FIRST REVIEW
WC³ Project #: 218-525-076
Weber County Project#: HSR 2018-01

Subject: Eisenberg - SFD – Plan Review Comments 1st Review

Project Name: Eisenberg - SFD

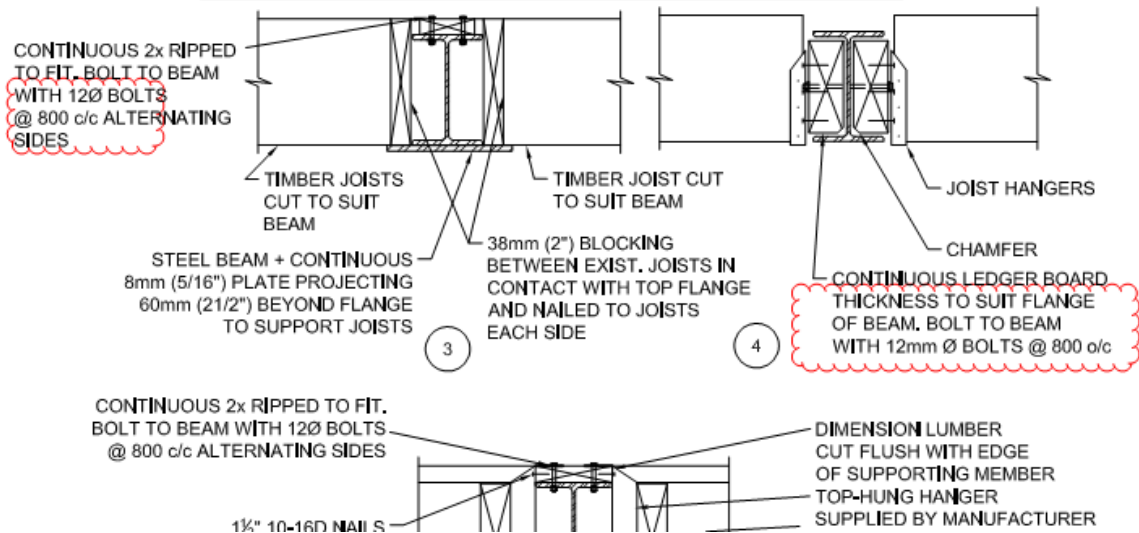
- S2. Sheet S001:
 - A. 010001 Design Notes: References are made to AISC 360-16 and AISC 341-16. These are not valid codes. IBC 2015 requirements are AISC 360-10 and AISC 341-10. Please verify and confirm that the design complies with current code requirements. (IBC Chapter 35)
 - B. 010001 Design Notes: Frost depth shows 40". Page 18 of Geotech's report indicates minimum 42". Please verify and revise the drawing. (IBC 107)
- S3. Sheet S003:
 - A. Reinforcement Development Lengths: The concrete strength provided in the table appears unusual. Please verify and consider revising to standard values compatible with ones shown on Sheet S001 Concrete Notes. It also references "Reinforcing Steel Manual of Standard Practice" which is a Canadian code reference. (IBC 107)

STEEL BEAM SUPPORTING JOISTS ON TOP FLANGE

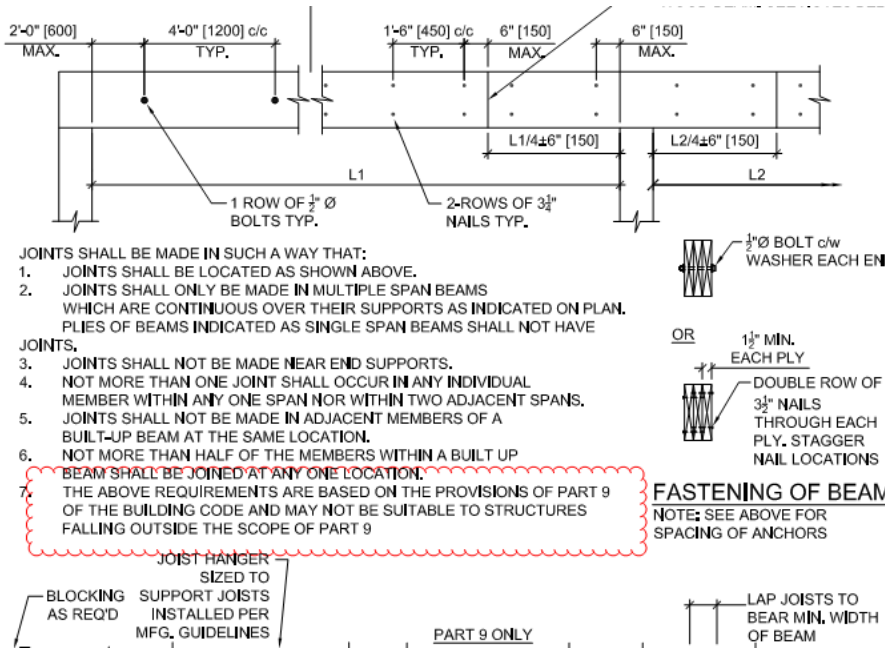
- A. Steel Beams Supporting Wood Joists: Units appear to be non-imperial. Please verify bolt diameter and spacing requirements. Please ensure all units are consistent. (IBC 107)

S5. Sheet S100:

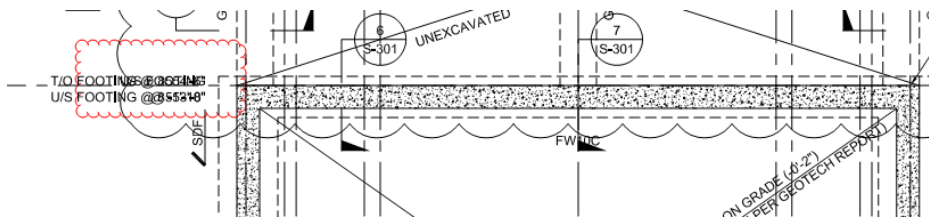
A. Notes on the plan are illegible. Please verify and revise the notes. (IBC 107)

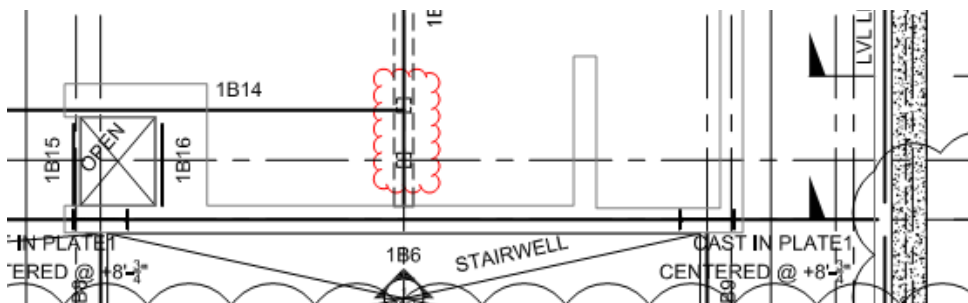
A. Member schedule note 4 refers to IBC 2304.9.5. Please verify if the intent was 2304.10.5.1 regarding fasteners protection. (IBC 2304.10.5.1)

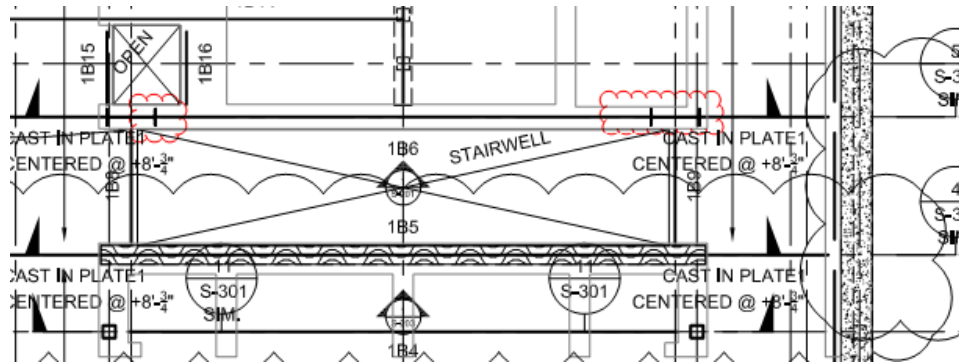
B. Posts information are unclear. Please verify load paths. Please indicate support information for all levels on the drawing. (IBC 1604)

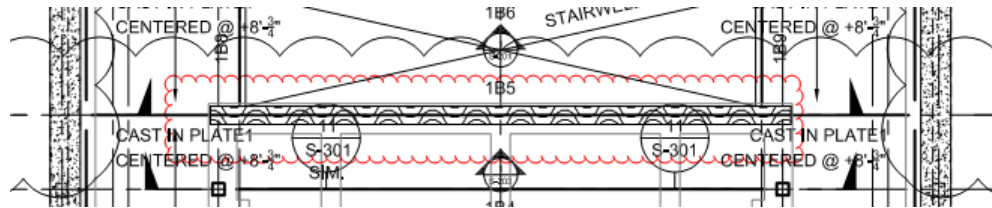
C. Please verify if 1B6 is part of the moment frame. The schedule appears to indicate this as part of the SFRS. Please provide moment frame indication on the drawing. (IBC 107)

S7. Sheet S200:

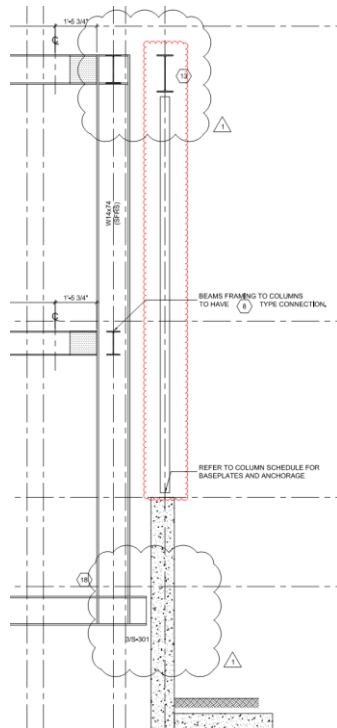
A. The walls appear to be isolated from the floors and moment frame. Please clarify load path of the walls out of plane condition. Structural walls shall be anchored to the roof and to all floors and members that provide lateral support for the wall. (IBC 1604.8.2)

S8. Sheet S203:

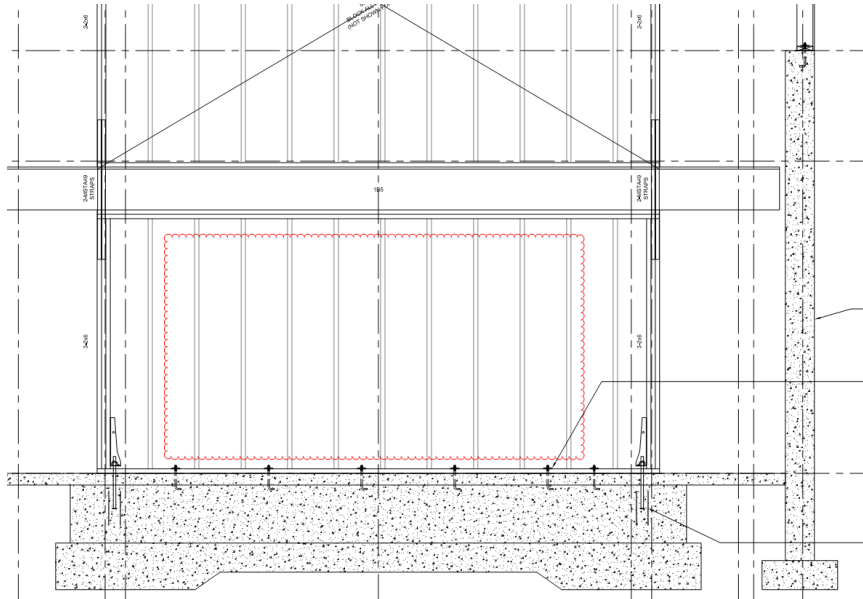
- A. Please verify if the wall is a shearwall. Walls above are shearwalls. Please verify load paths. If this is not a shearwall, the condition appears to create a vertical in-plane discontinuity irregularity. Please verify that the increase load requirements of ASCE 7 12.3.3.3, 12.3.3.4 have been satisfied. (ASCE 7 T12.3-1)

S9. Sheet S300:

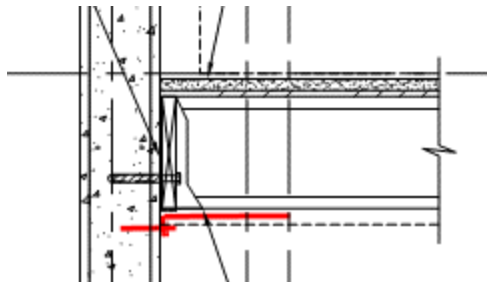
- A. Please verify that walls are tied to the diaphragm. Structural walls shall be designed to resist bending between anchors where the anchor spacing exceeds 4 ft. Wood ledger shall not be used in cross grain bending. Plywood sheathing may not be used in direction tension or compression conditions. Please show parallel joists conditions. This applies to details on other sheets as well. (ASCE 7 12.11, 12.11.2, 12.11.2.2.3)

- B. Diaphragms shall be provided with continuous ties or struts between diaphragm chords to distribute wall anchorage forces in to the diaphragms. Please indicate these chords on the drawing. (ASCE 7 12.11.2.2, 12.11.2.2.3)

S10. Sheet S301:

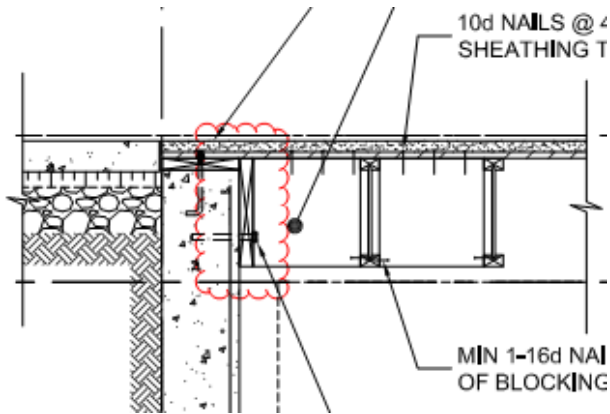
- A. Detail 6: Wood framing members in direct contact with the interior of exterior concrete walls below grade shall be of naturally durable or preservative treated wood. Please verify and indicate on the drawing. The condition applies to other details also. (IBC 2304.12.1.3)

S11. Sheet S401:

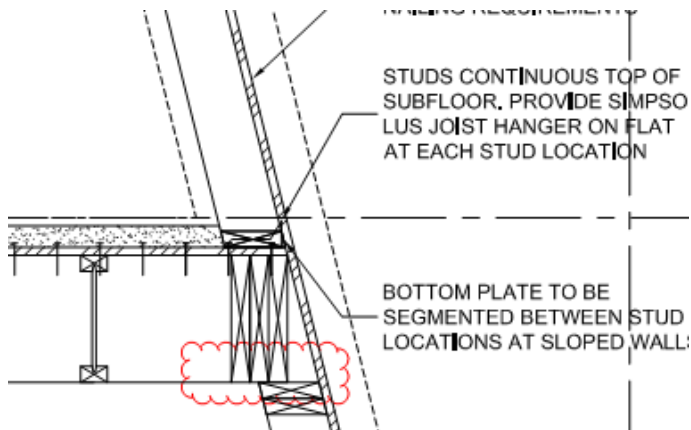
- A. The built-up beam appears to be partially supported. Please verify bearing condition. (IBC 1604)

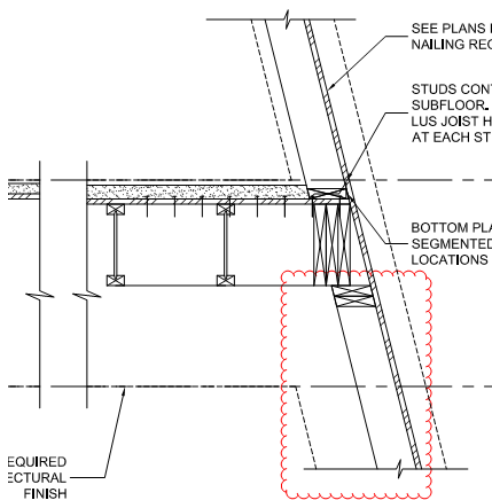
- B. The supporting studs appear to be sloped. The stud capacity may be reduced. The condition also creates additional eccentricity. Please verify that this and P-delta effects have been considered.

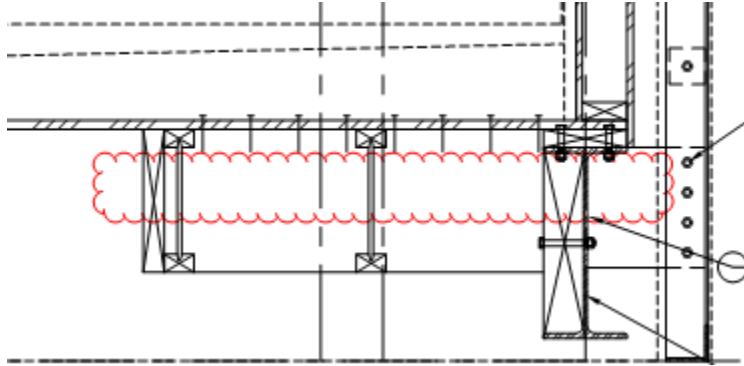
C. Detail 3: Threaded rods appear to be missing from the detail. Please verify and revise. (IBC 107)
